WAIMAKARIRI DISTRICT COUNCIL

SECTION 42A REPORT

FILE NO: RC215210 RC225279/ 221111196864

SUBJECT: Publicly notified subdivision and land use consent application

Figure 2: Flood risk map (Low- green, Medium- blue).

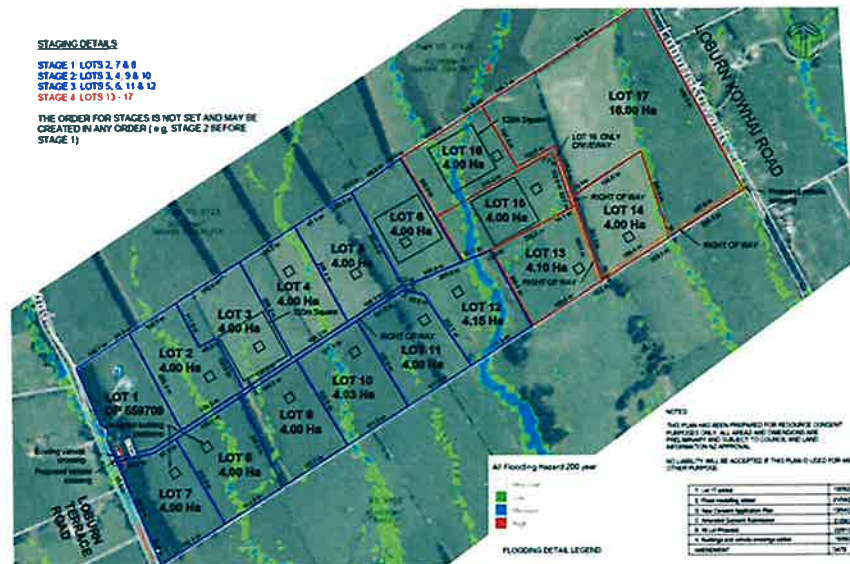
62. Ms Morgan has considered flood hazard in relation to the site. The site is subject to a low to medium flood hazard from overland flows during a 1 in 200yr AEP flood event. This is largely due to the site being rolling with all overland flows following valleys within the site. Ms Morgan does not consider that flooding for the site is expected to be an issue. All building platforms are located outside of the overland flows generated via local flooding. This requirement would need to be conditioned and secured by a consent notice placed on each record of title, if subdivision consent is granted.

63. Ms Morgan has noted that the ROWs which cross the overland flow paths will need to be designed to not affect or alter overland flows. Current NZ standards is that a site should be able to gain access in a 1 in 50yr AEP event. From looking at the 1 in 100yr AEP event the maximum flood depth across the ROWS is 1m within valleys. As the source of flooding is from local valleys, the flow rate is expected to be low and as such flooding for the site is not expected to be an issue. Suitable conditions are recommended, if subdivision consent is granted.

64. Taking into account Ms Morgan's expert assessment, and subject to appropriate conditions, I consider the effects of flooding from the overland flow paths on the sites and Right of Ways will be less than minor.

Proposed subdivision plan

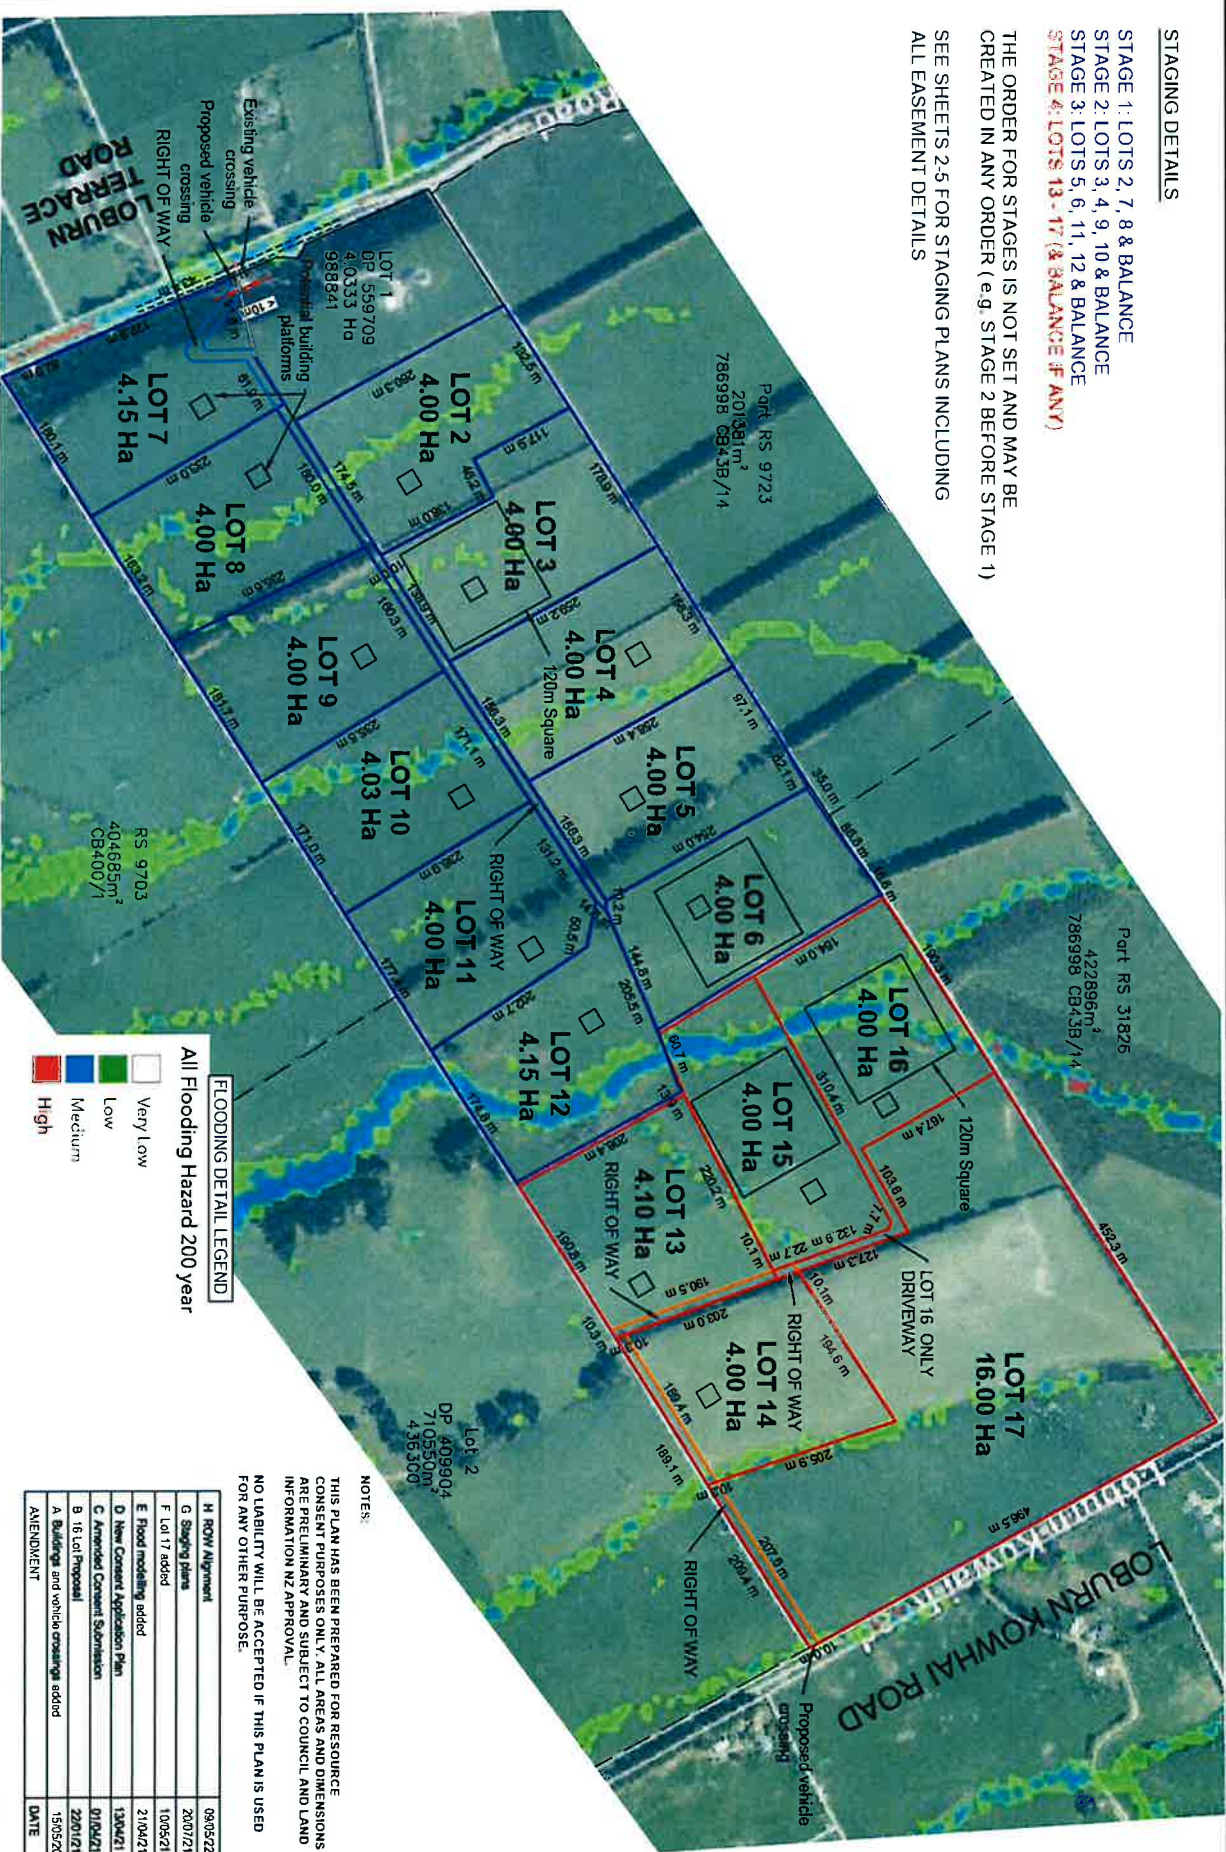
47. The initial application was redesigned to enable an appropriate grade of access from Loburn Terrace Road, which traverses the escarpment. The access is located immediately adjacent to the previous allotment that was subdivided off the site and meets the requirements for separation distances under the operative plan. The subdivision design follows an evenly dispersed approximately 4 hectare block pattern, with potential building platforms for each proposed allotment. I consider that for rural lifestyle use, that the subdivision design shows a logical pattern, with potential house sites and evenly distributed boundaries on the rolling land.

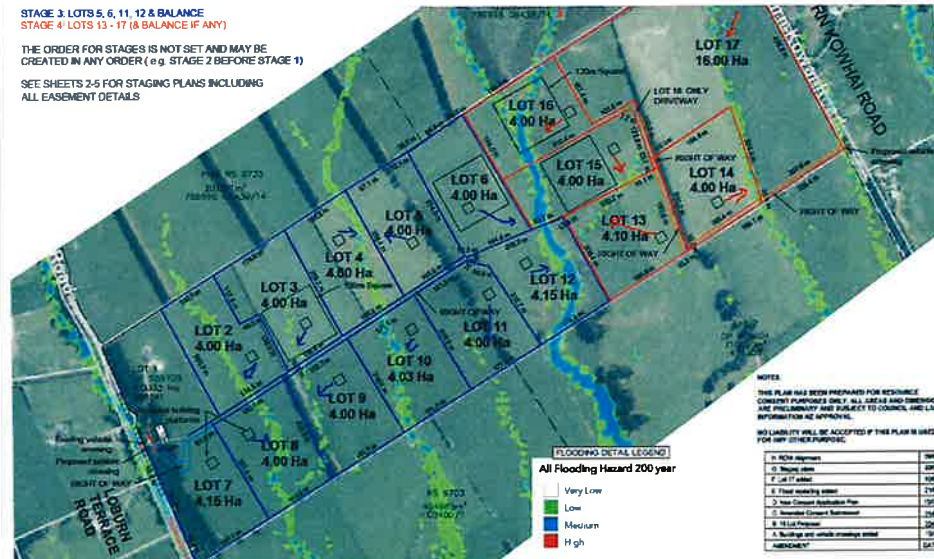
From looking at nearby building consent applications the majority of applications had stormwater being discharged via soak pits with only two properties found to be utilising onsite retention ponds or retention tanks.

A quick assessment of the site was also completed to ensure that all Lots had adequate access to secondary overflow paths which don't affect or cross neighbouring Lots or properties in rainfall events greater than a 10% AEP. Extended overflow lateral may be needed to ensure the overflow runs into the nearest valley however none of which will need to cross neighbouring Lots.

Assessment under previous DP 4Ha rule

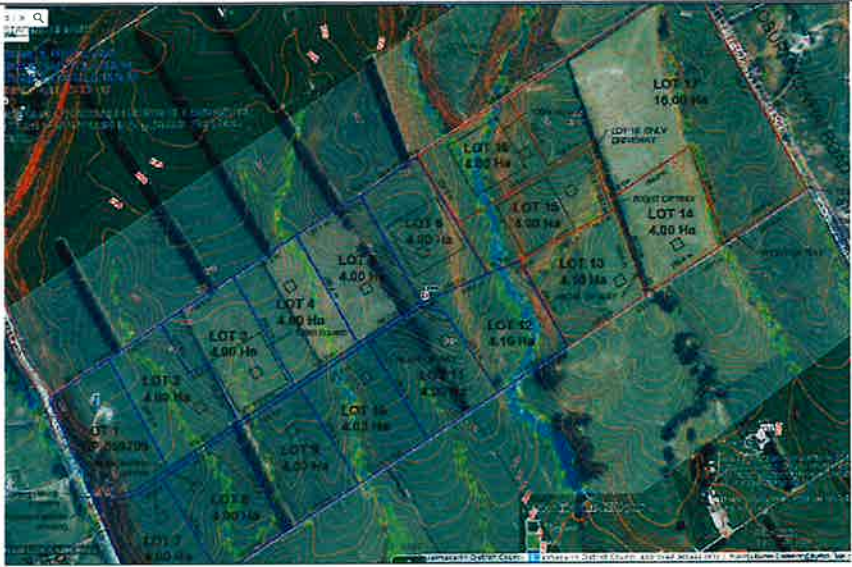
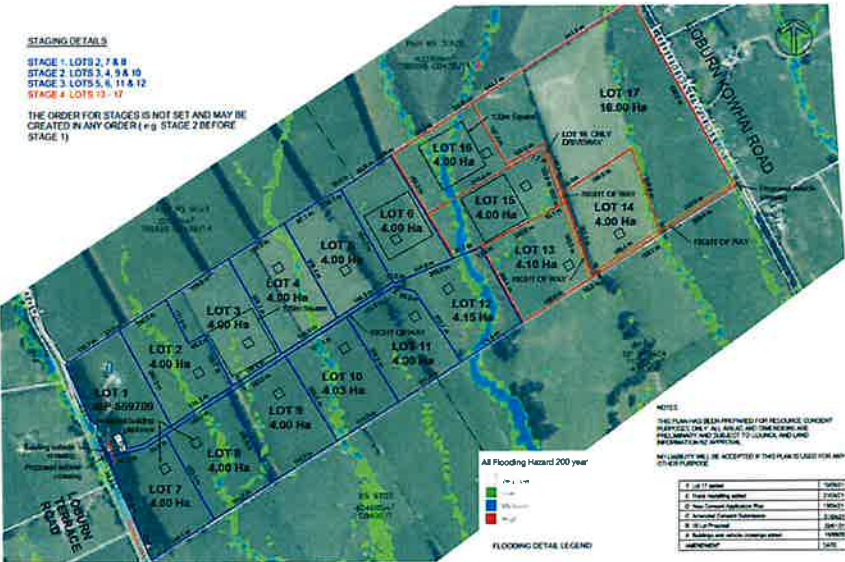
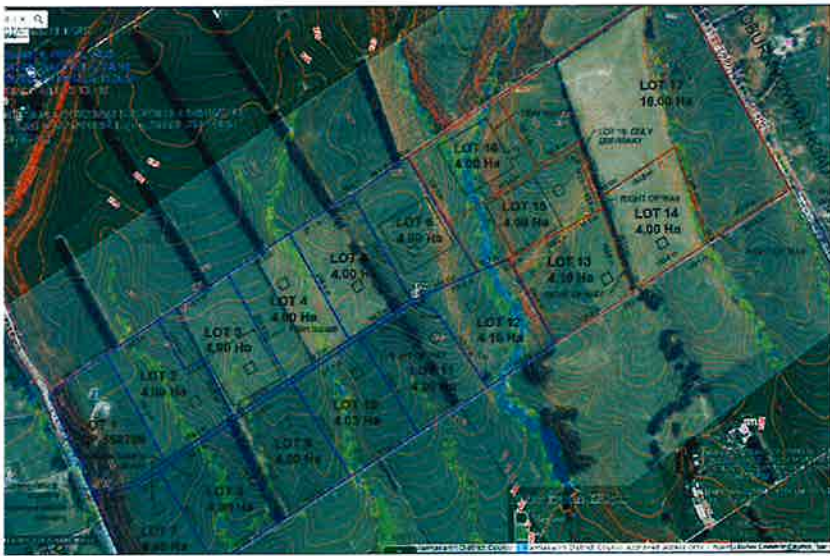
Loburn Terrace Road is proposed to serve Lots 2 to Lot 12 under this application resulting in an additional 11 new Lots accessing from the road. Loburn Terrace Road is classified as a local rural road with an all-weather (gravelled) formation width of 6m, with the nearest sealed section of the road being 1.4km south-east of the site at 239 Loburn Terrace Road.

Under this application the additional lots will create a total of 88 vmpd (11 lots x 8vmpd). The ADT for Loburn Terrace Road as of the Dec 2020 is 195vmpd.

Similarly, to Loburn Kowai Road, under NZS4404:2010 the required road width of 5m to 5.5m is deemed adequate for a standard rural road, however, Loburn Terrace Road does not meet current council design standards or DP rule 30.1.1.9. and as such financial contributions can be assessed to upgrade the road.

A total of 39 potential Lots could be created by neighbouring properties who will also use this road for access. This adds up to a potential final traffic count for Loburn Terrace Road of **595** vehicle movements per day ($88 + (39 \times 8)$)

<p>+195). This meets the threshold for sealing, and shoulders and gravel berms would need to be installed as well.</p> <p>For this situation, the proposed 88 additional vehicle movements proposed accounted for 14.79% of the final traffic count and hence only had to pay for 14.79% of the total cost of sealing the road.</p> <p>Assessment under current DP 20Ha rule</p> <p>Under the recently imposed DP rule, only an additional six 20Ha lots could be subdivided in the area. This would reduce the final traffic count to 331 vehicle movements per day ($88+(6*8) +195 = 331$).</p> <p>As the forecast vehicle movements are within 300-400 vmpd threshold, sealing of the road is still triggered, though only just. It is noted that with the reduced number of future lots in the area, the consent holder would be contributing 26.59% towards the estimated cost of sealing the road instead of the originally calculated 14.79%. The cost calculated also include widening the road by adding a 0.5m sealed shoulders and a gravel berm either side in accordance with Councils rural roading design standard drawing 600-270 issue D</p> <p>Summary</p> <p>Under the 4ha area rule and 20ha area rule FC calculation is need for Loburn Terrace Road to be sealed with widening occurring by installing 0.5 sealed shoulders and a 2.25m gravel berms either side.</p> <p>A full breakdown of the costs can be found on Council files 221108194701.</p> <p>Note that as per Council's <u>rural seal extension policy</u> and the Long term Plan (LTP), Council has signalled it does not wish to fund seal extensions unless it qualifies for subsidy from NZTA. However, if at least 30% of the cost of sealing is contributed through financial contributions Council will undertake the sealing works.</p>
